UNITED STATES PATENT AND TRADEMARK OFFICE

| APPLICATION NO. | FILING DATE | FIRST NAMED INVENTOR | ATTORNEY DOCKET NO. | CONFIRMATION NO. |
|--|-------------|----------------------|-------------------------------|------------------|
| 09/963,577 | 09/27/2001 | Ryoichiro Uehara | 05711.0122 | 9686 |

Office Action Summary

DETAILED ACTION

【圖1】

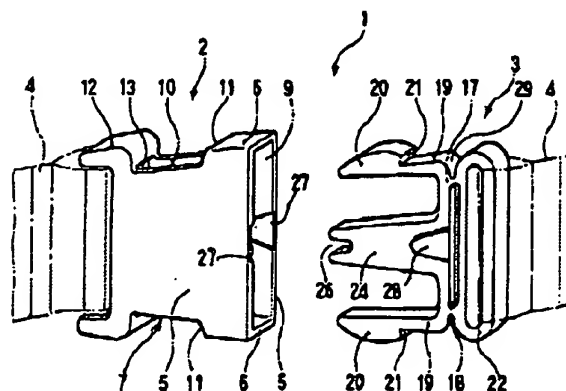
JP 8-131215 (figures 1, 2, 6, 13, 14, 16, 17) teaches a buckle comprising a female body 2 formed with a flat housing and a male body 3 having flexible insertion legs 20 which are engaged with each other by insertion, each of the female body and the male body having a front surface, a rear surface, and right and left

side faces, and having butting portion including straight portions 18 and a convex portion 28 formed on the front surface of the male body and a concave portion 27 with straight portions defined by the edge of the mouth of the female body on the inside surface of the front face of the female body 2, wherein the concave 27 and convex 28 portions are formed at a center of the butting portion sandwiched by the straight portions 18 on the male body and the corresponding straight portions of the female body, the convex portion 28 in the butting portions protrudes in a wedge-shaped form with a rounded narrowed leading edge while the concave portion 27 is dented with the inlet expanded, the female and male bodies are thereby formed closely in contact at the butting portions, a guide 24 is protruded linearly from a center of a front end of the convex portion 28 of the male body, and partition pieces 16, 25 for guiding the guide member on a same line as an axis line of the guide member are provided on an inner surface of the housing of the female body.

The side view shown in figure 1 shows the convex portion and straight portions being notched to a one level lower stepped portion which fits into the female body so as to be overlapped thereby.

As to claim 3, JP 8-131215 shows in figure 1 the concave and convex butting surfaces formed on both front and rear surfaces of the male and female bodies.

In regard to claim 4, JP 8-131215 shows in figure 1 the concave and convex butting surfaces sandwiched between straight butting portions formed on both front and rear surfaces of the male and female bodies. Claim 4 requires butting straight or linear-form butting portions on two opposite sides and the convex and concave portions on one side. JP 8-131215 shows this. Claim 4 is silent on prohibiting other butting configurations such as convex and concave on the opposite surface. There are no limitations in claim 4 to prohibit convex and concave portions on both sides.

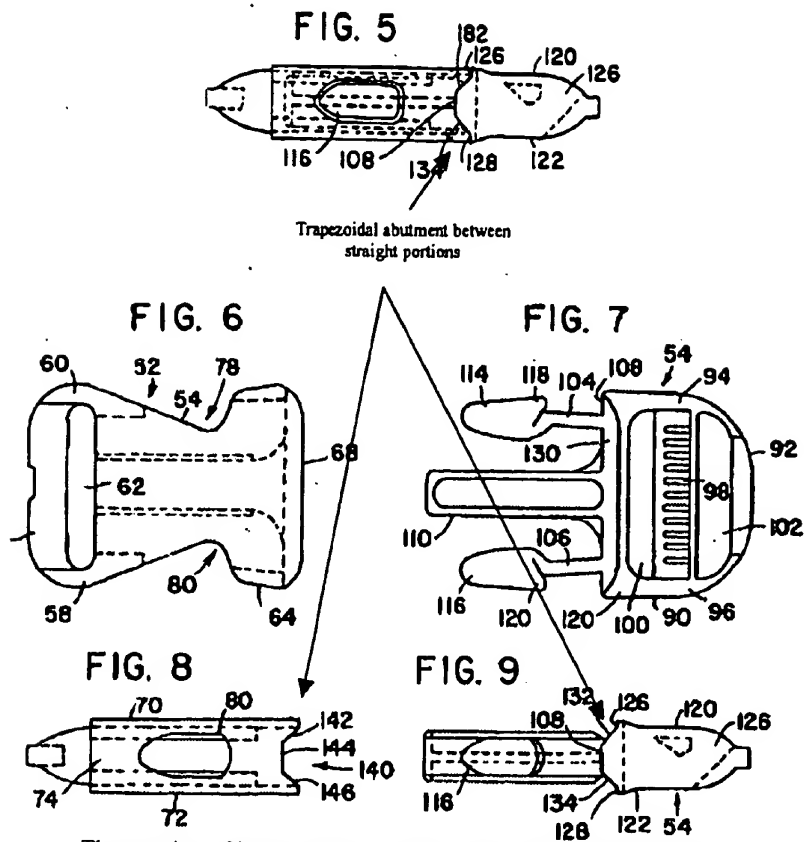
The difference is that the convex portion is not trapezoidal and the concave portion does not extend through the thickness of the front face of the female body so as to exist on the front surface. However, Krauss (figures 5-9) teaches a buckle similar to JP 8-131215 and further suggests the use of a trapezoidal butting guide 132, 134, 108 positioned on opposite side faces of the male body fitting into cooperating recesses 142, 144, 146 on side faces of the opening of the female body that extend completely through the side faces so as to provide a geometry well known in buckles to provide stable interengagement between the male and female bodies.

As the JP 8-131215 buckle is designed to have butting convex and concave surfaces on the male and female bodies, respectively, so as to inherently interlock the male and female bodies together at the mouth of the female body against relative lateral movement and it would be advantageous to have the lateral torsional loads well distributed across the front faces of the male and female bodies to the side faces while maintaining square alignment during insertion and preventing lateral movement, it would have been obvious to modify the buckle of JP 8131215 so that the butting portions are trapezoidal in view of Krauss (figures 5-9) teaching the use of a trapezoidal butting guide 132, 134, 108 on the male body fitting into a cooperating recess 142, 144, 146 extending completely through a minor face of the opening of the female body so as to provide a geometry well known in buckles to provide stable interengagement between the male and female bodies so that torsional forces can be well distributed while providing sure guidance and preventing side to side movement. So far as understood, the combination of references provides the continuous relationship that applicant claims.
